Addendum #001

Quote Request # 07-12-22-01

Sidewalk Replacement at T.B. Watkins 1301 Vine St. KC MO 64106

More Locations: 917 thru 923 Woodland Ave. (Wayne Miner) added to initial scope.

921- 923 Woodland Ave. WAYNE MINER (to South direction)

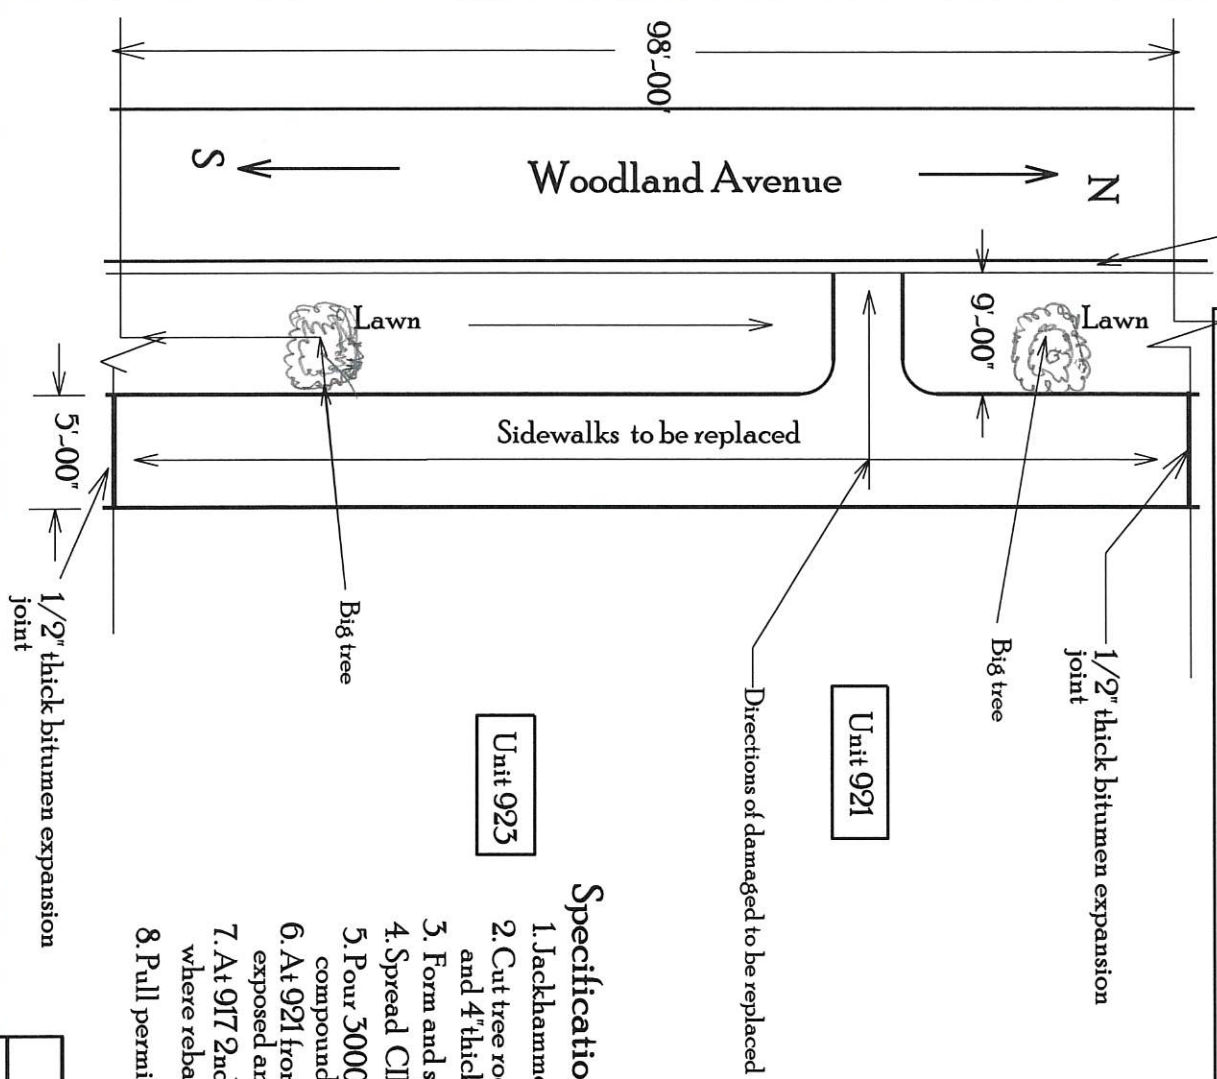
Sidewalk along 921 thru 923 Woodland Ave (Wayne Miner) to South Direction.

1. Jackhammer, remove sidewalk & excavate for gravel base & sidewalk
2. Cut tree roots as much as possible to allow spread 2" thick gravel base and 4" thick sidewalk
3. Form and spread 2" gravel base
4. Spread CP, 6x6, W1.4x W1.2 mesh and 1/2" dia dowels rebars
5. Pour 3000psi concrete Sidewalk & finish with concrete curing compound
6. At 921 front step landing, cut & remove weak concrete where rebar exposed and neatly patch the edge
7. At 917 2nd step nose or edge, cut out and remove weak concrete where where rebar is about to exposed and neatly patch the edge with the mortar
8. Pull permit from City Public work, submit the permit and approval

921- 923 Woodland Ave. WAYNE MINER (to South direction)

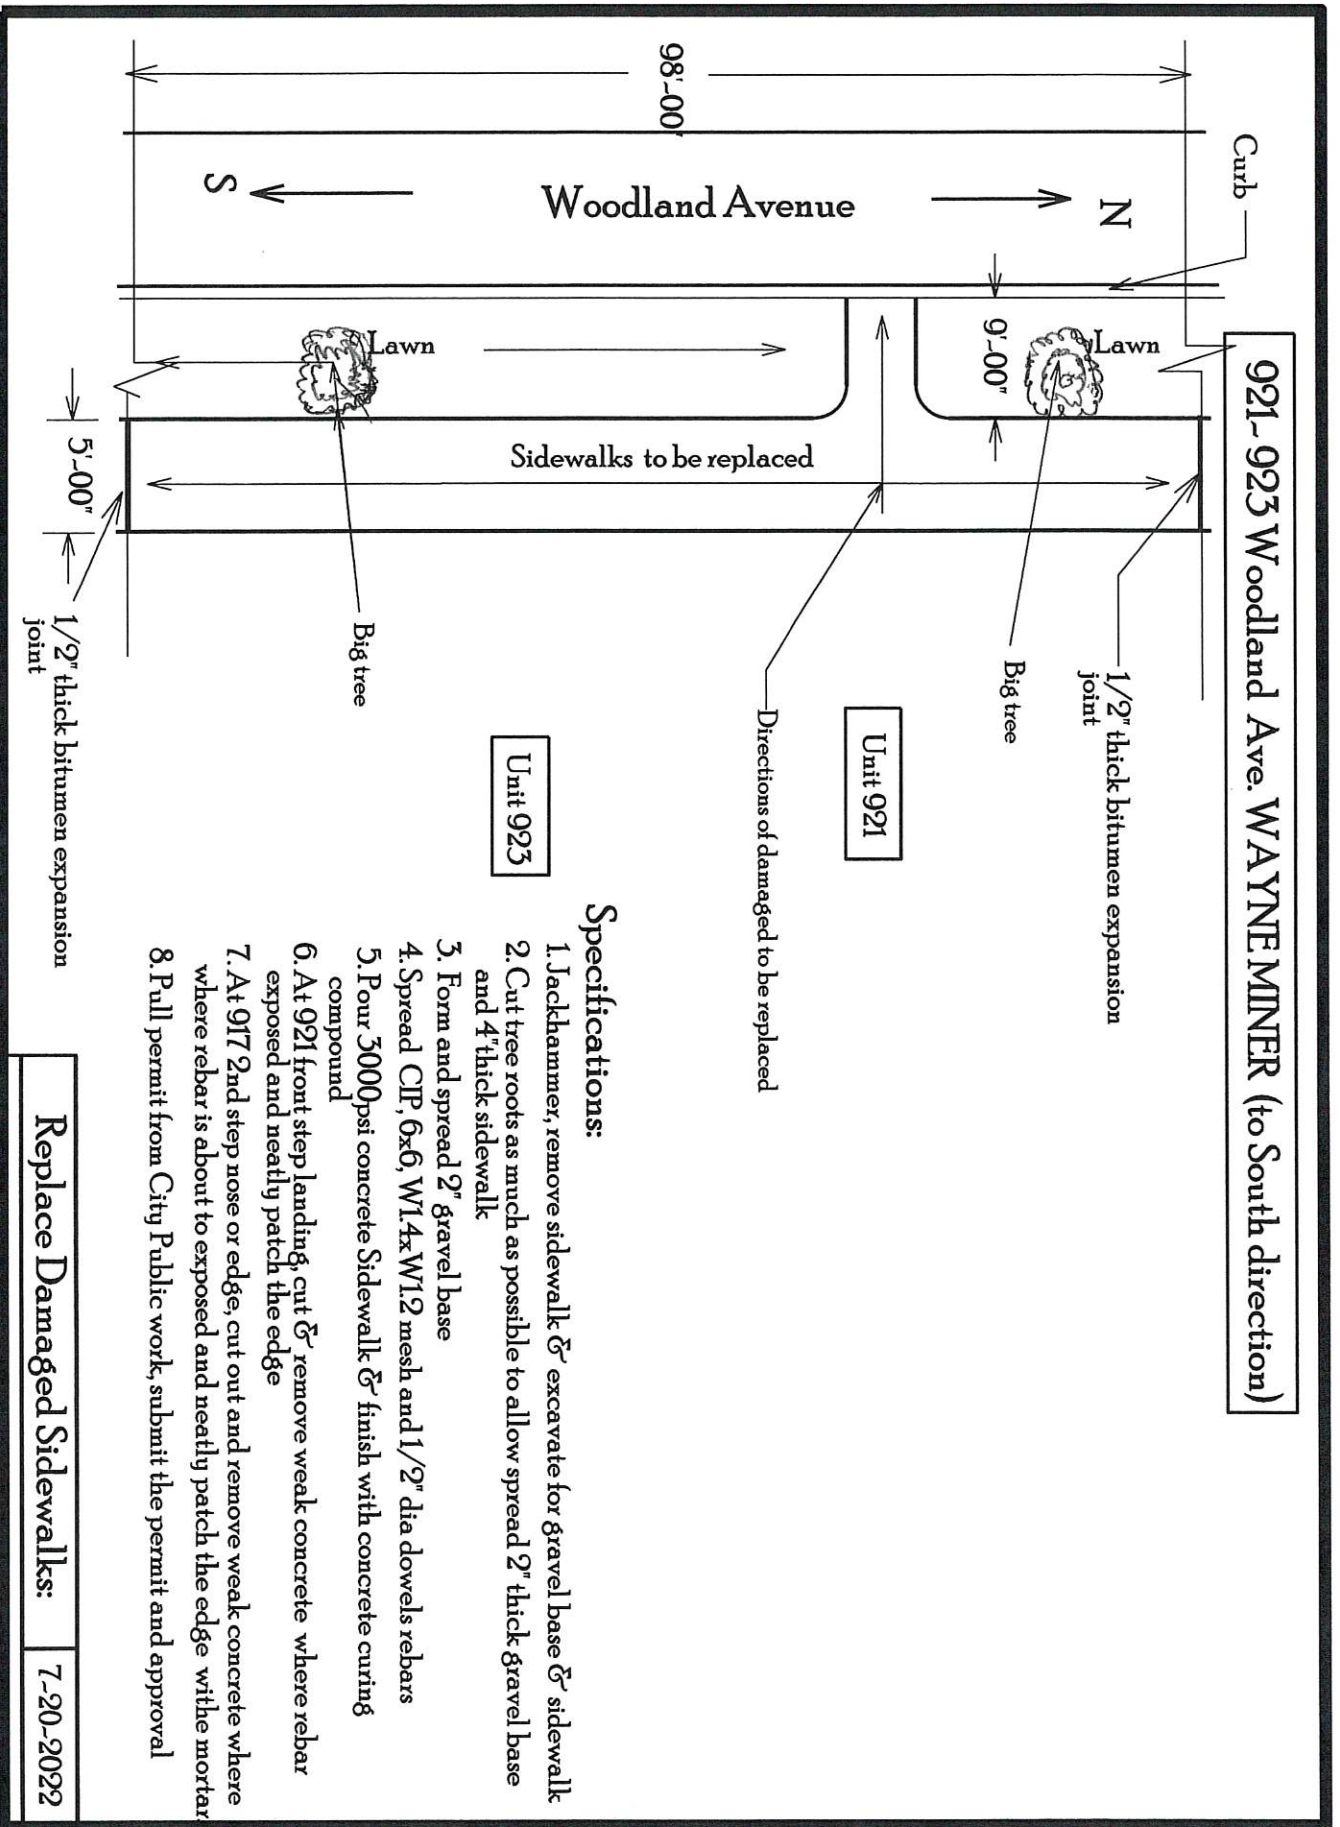
Unit 923

Unit 921

1. Jackhammer, remove sidewalk & excavate for gravel base & sidewalk
2. Cut tree roots as much as possible to allow spread 2" thick gravel base and 4" thick sidewalk
3. Form and spread 2" gravel base
4. Spread CP, 6x6, W14xW12 mesh and 1/2" dia dowels rebars
5. Pour 3000psi concrete Sidewalk & finish with concrete curing compound
6. At 921 front step landing, cut & remove weak concrete where rebar exposed and neatly patch the edge
7. At 917 2nd step nose or edge, cut out and remove weak concrete where where rebar is about to be exposed and neatly patch the edge with mortar
8. Pull permit from City Public work, submit the permit and approval
